**1.1 ADDENDUM FORM**

- .1 This Addendum forms part of the Contract Documents and modifies the Bidding Documents dated August 20, 2018, with amendments and additions noted below.
- .2 Acknowledge receipt of this Addendum in the space provided in the Bid Form. Failure to do so may disqualify the Bidder at the Owner's discretion.
- .3 This addendum consists of six (6) pages plus the following list of attached drawings:

PROJECT INTERIOR RENOVATIONS  
 CONTENTS REVISED PHASING PLAN

CLIENT FEDERAL BUILDING

**AREA AND PHASING PLAN**  
 1 : 150

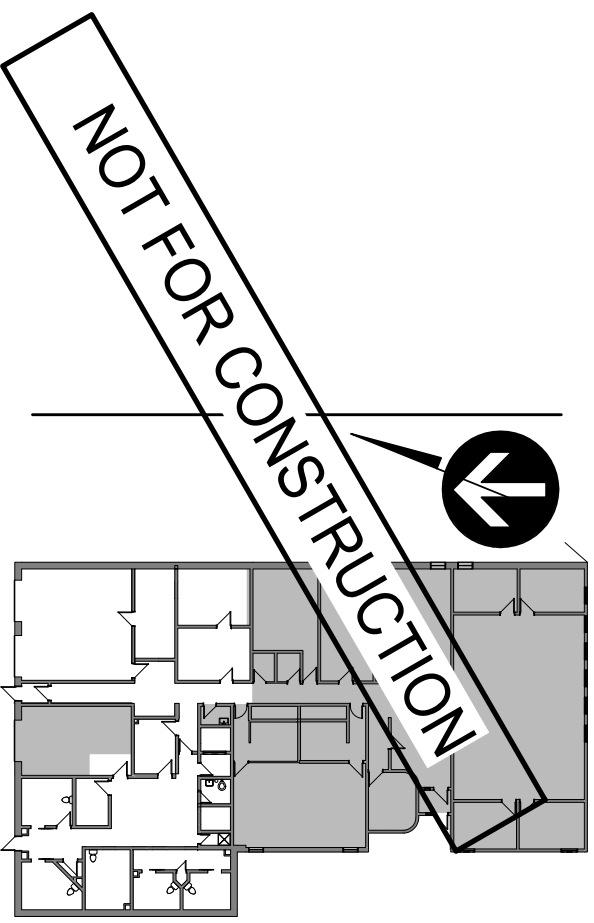
- .1 DRAWING A0.1, Detail 3/A0.1 Area and Phasing Plan
  - .1 Refer to enlarged Detail 1/R1. **Revise** phase 1 and 2 as indicated.
- .2 DRAWING S2 Partial Existing Attic & Roof Framing Plans

RAI Response: Phases to be swapped, cells are to be completed in phase 1. Phase 1 will require to be completed by June 30th, 2019. Refer to revised drawings.
- .4 Temporary sea can in room 131, is there any required specifications for this sea can? Would you consider a temporary secure storage area built from steel studs or lumber in lieu of a sea can?

CONTENTS  
DEMO AND NEW CONSTRUCTION FLOOR PLAN, ELEVATIONS

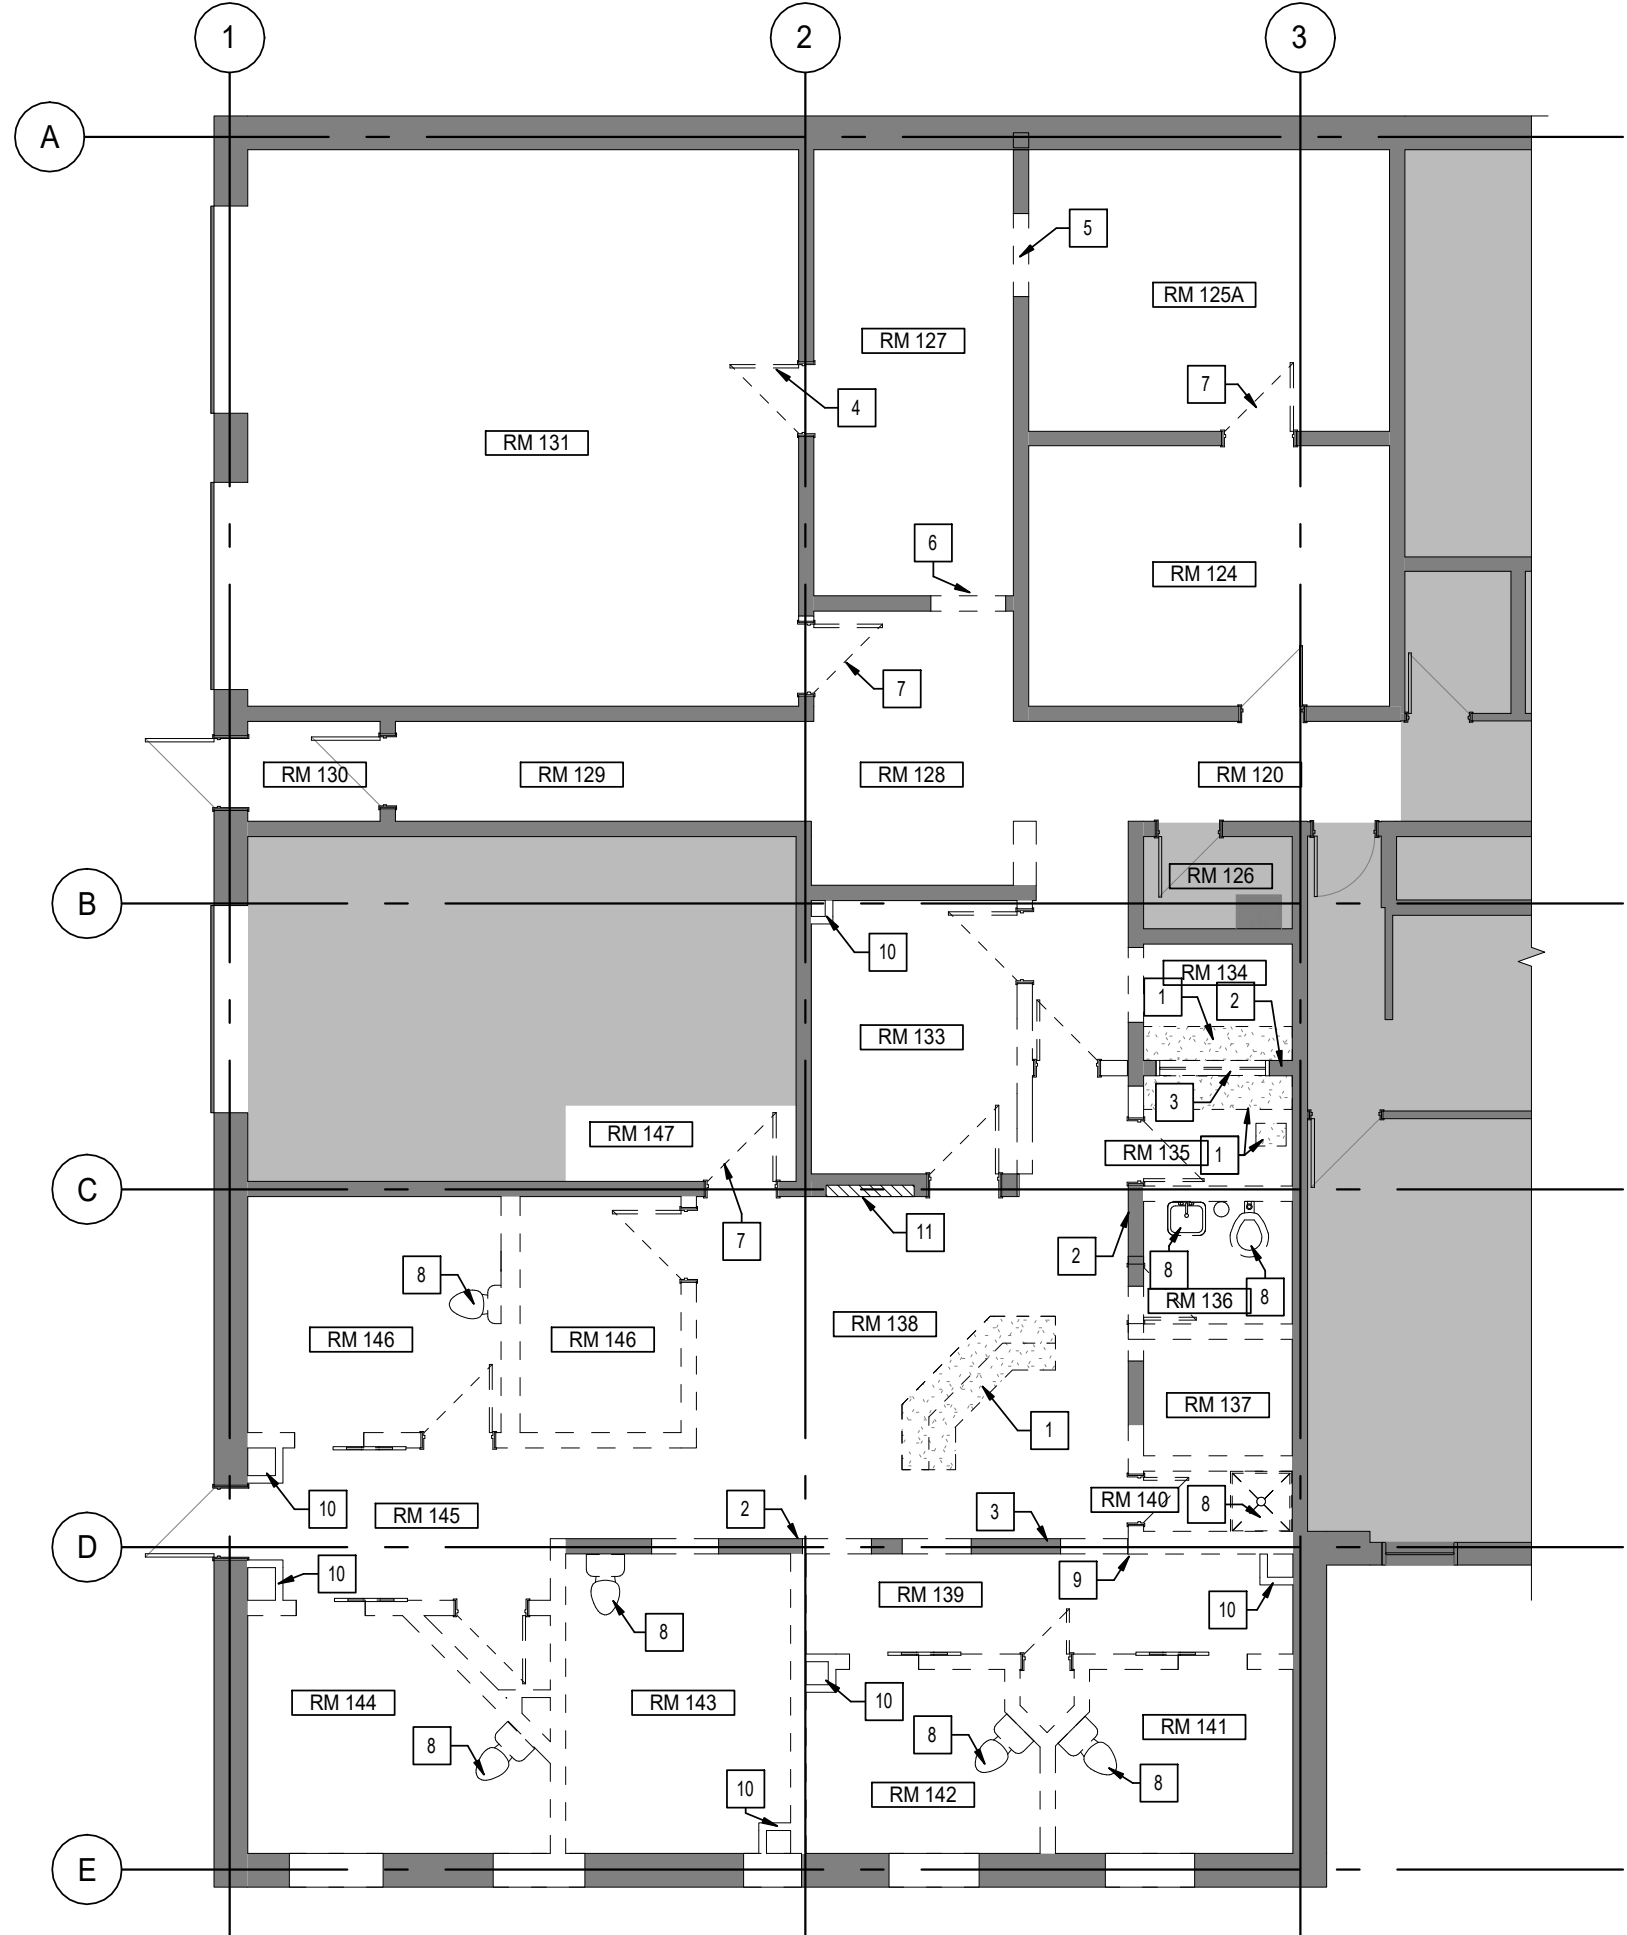
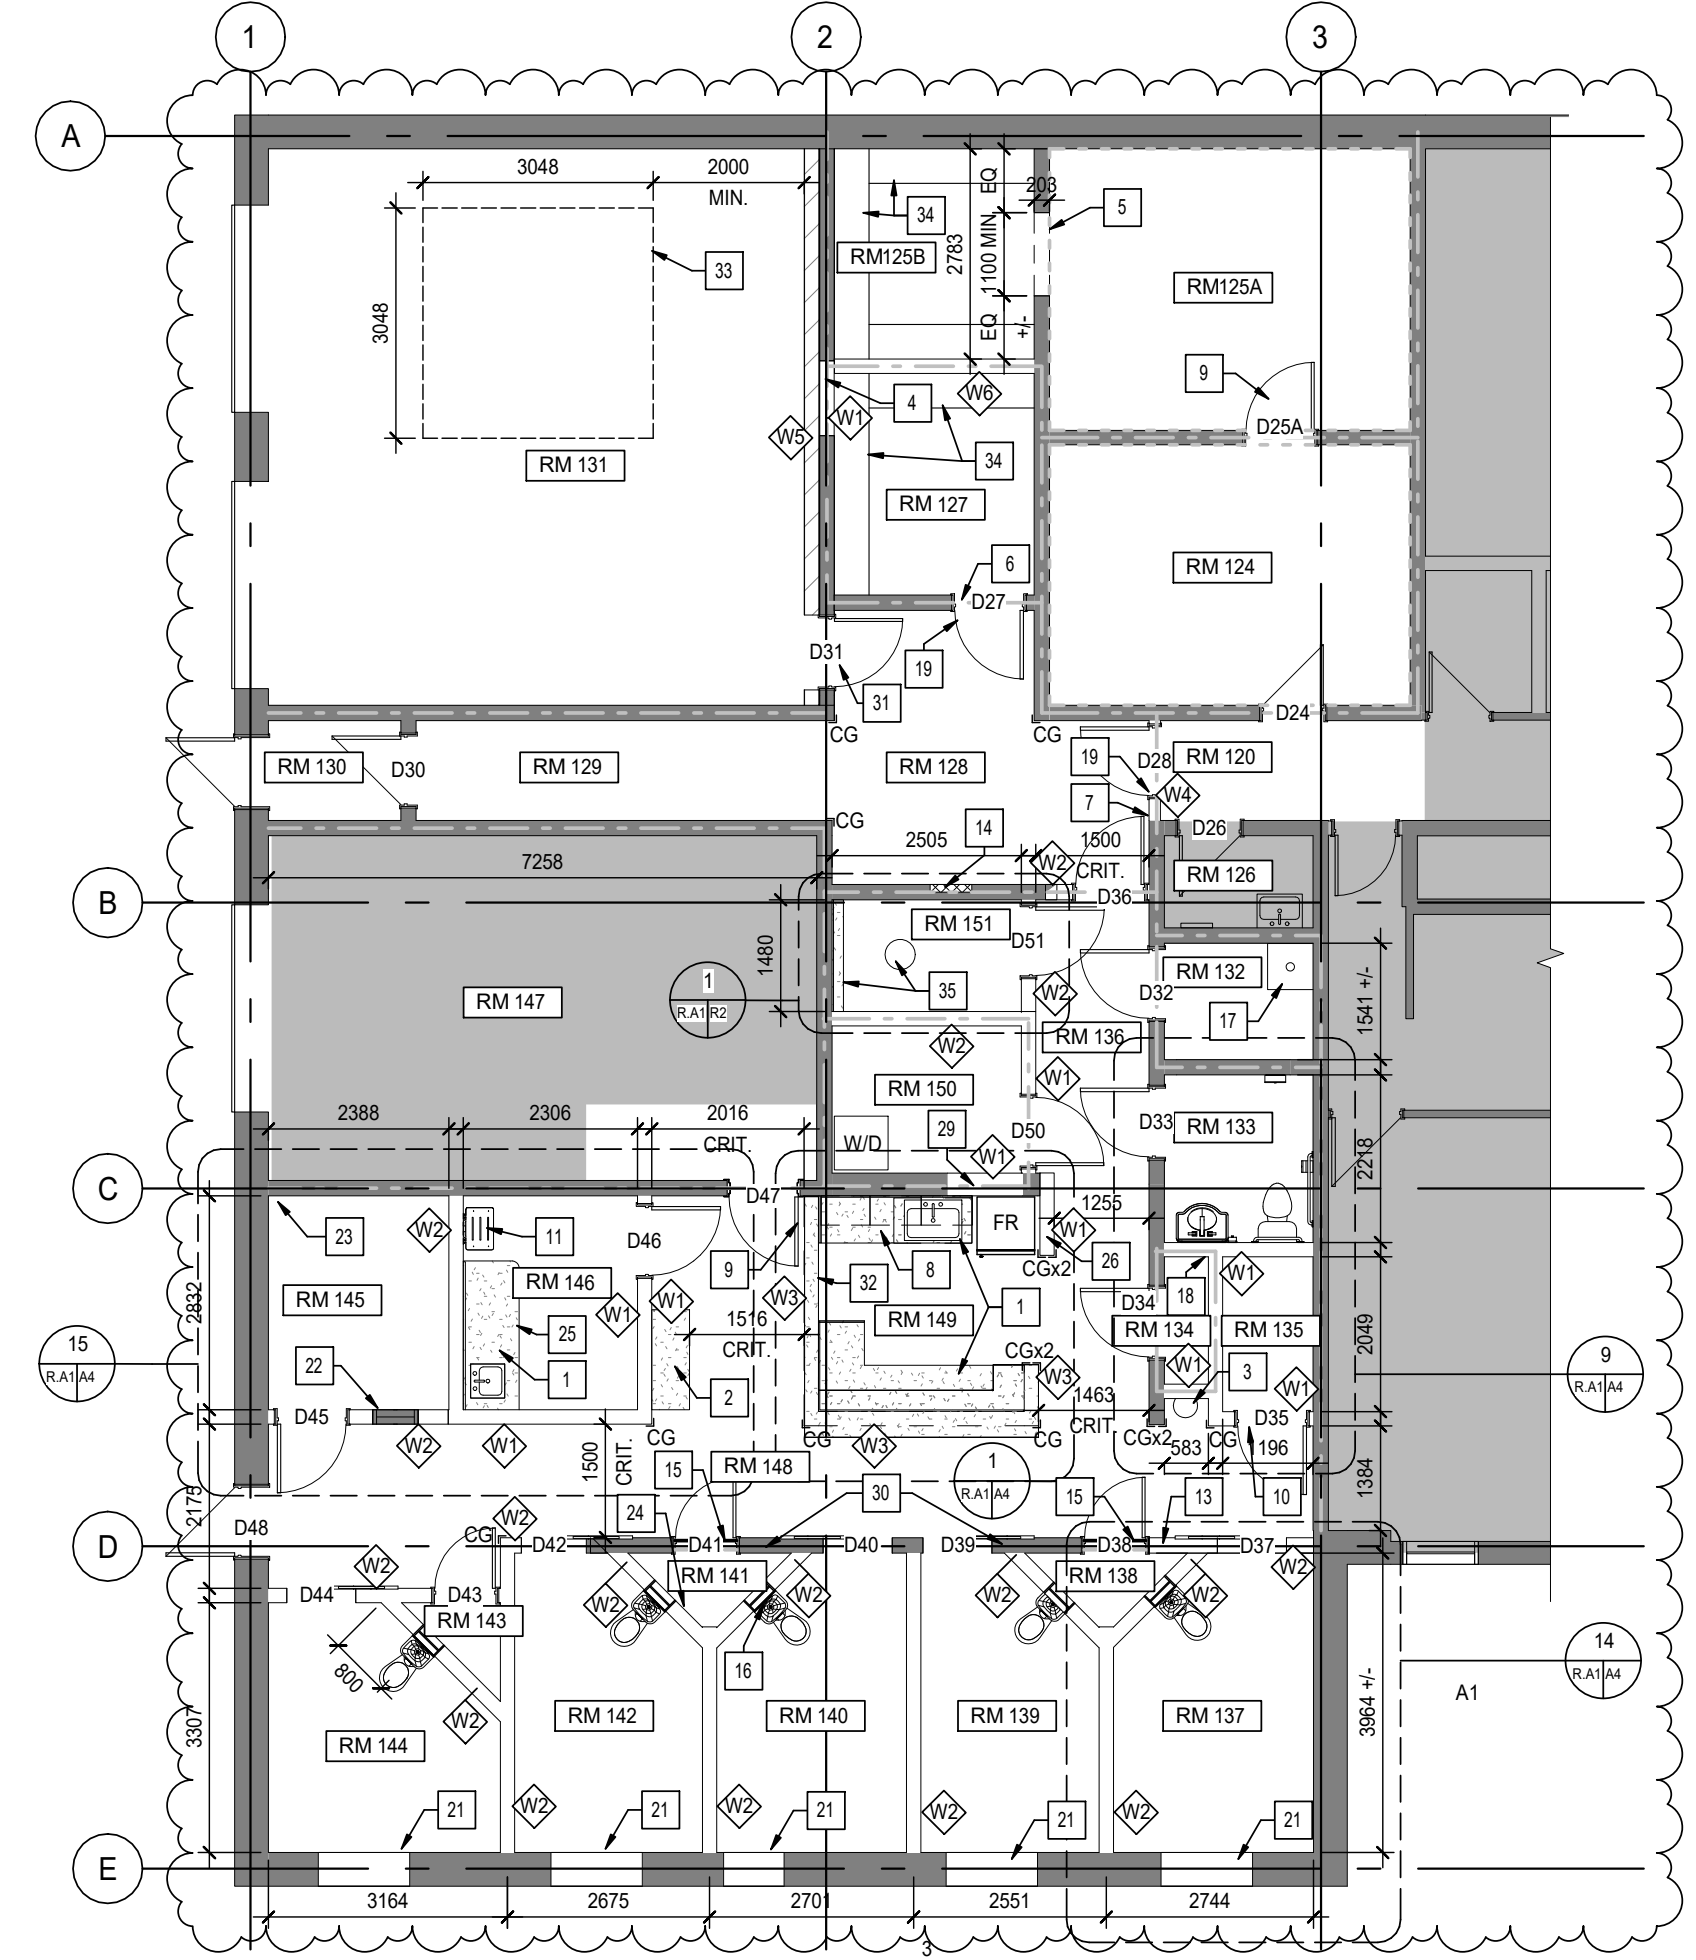
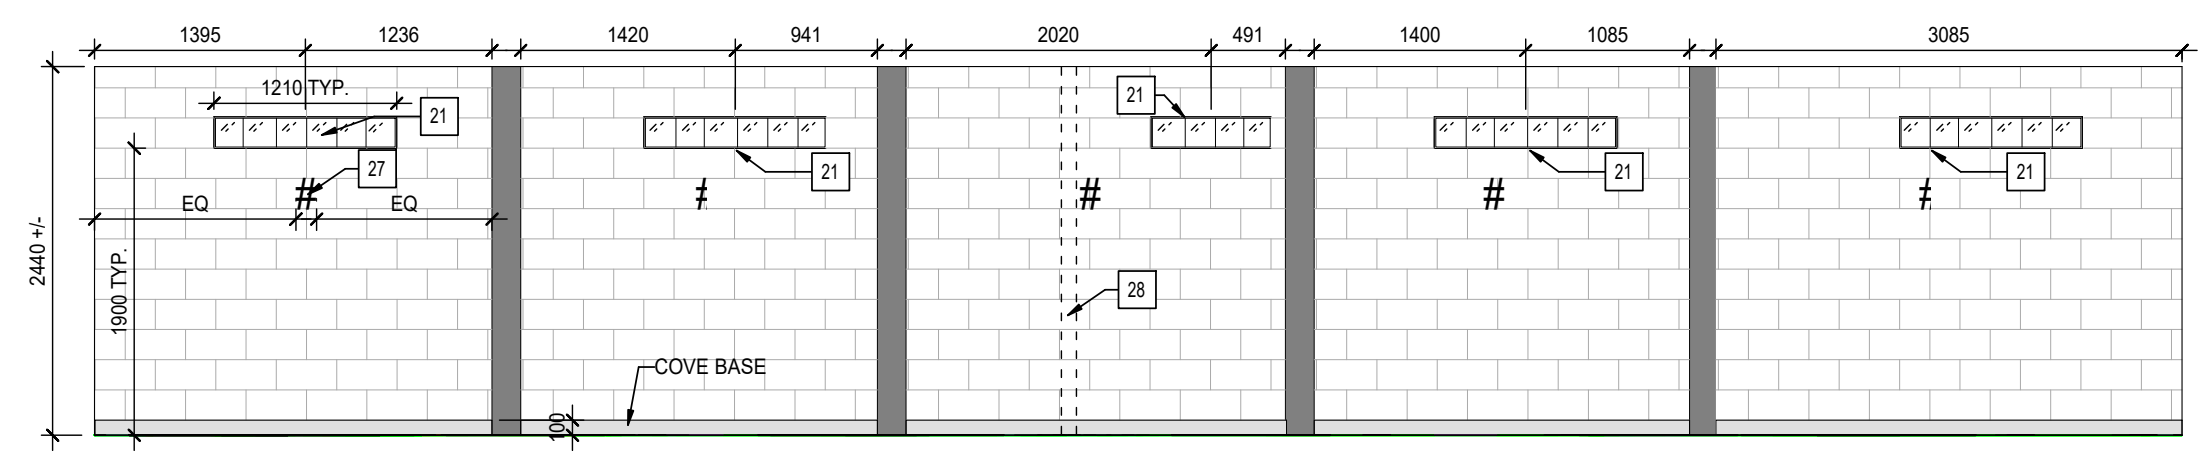
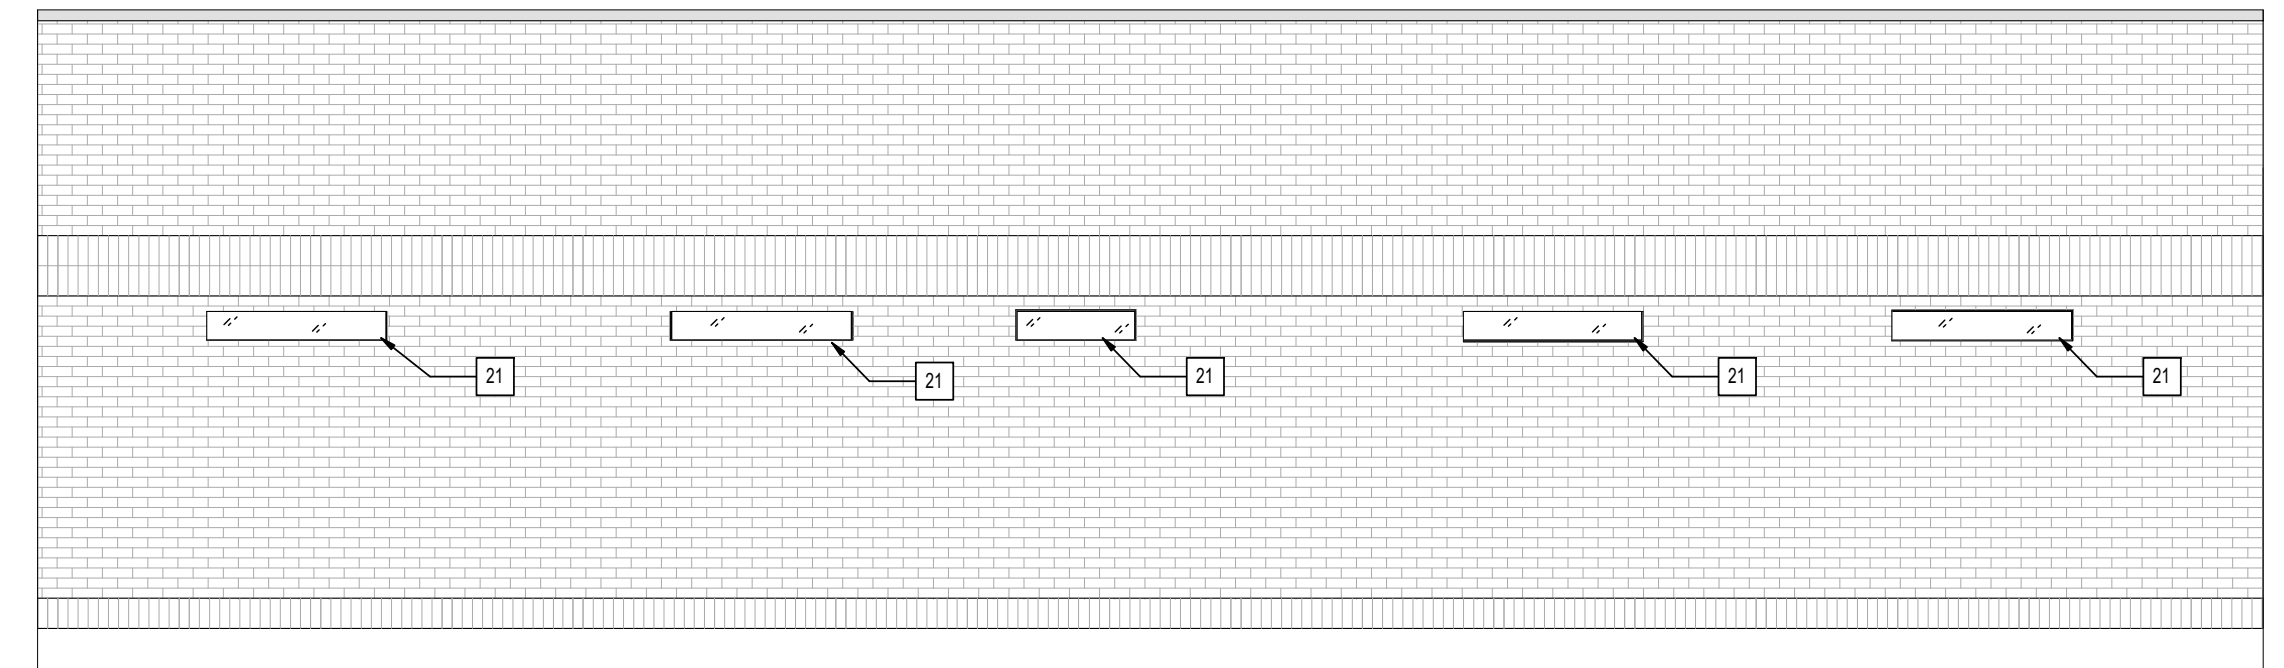
- .3 DRAWING RA1 Demo and New Construction Floor Plans, Elevations
  - .1 **Add** secure enclosure with roof in room 131. Ensure 2 meters of clearance is maintained between enclosure and new wall along gridline 2.

- .2 **Add** metal shelving in Room 125B and Room 127.
  - .3 **Add** corner guards throughout as indicated.
  - .4 Rooms 124 and 125B to be smoke tight. **Revise** wall types as indicated.

- .5 **Add / Revise** new construction keynotes 33-35 and general construction notes 12-13 as indicated.
- .4 DRAWING R2 Room 151 Details
  - .1 **Add** millwork in Room 151 as indicated.

RAI Response: Shelving to be located along East and West wall of room 125B. Refer to revised drawings.
- .3 Does Phase 1 have to be completed before moving onto phase 2 or can they be done at the same time?

RAI Response: A temporary secure enclosure with ceiling has been included in Room 131.
- .5 I cannot find specifications for the following: Eyewash Station, Wall Mounted Foldable Chair/Bench, Door D51 Frame Type 5.

RAI response: Yes, these are required. Refer to drawing revisions.
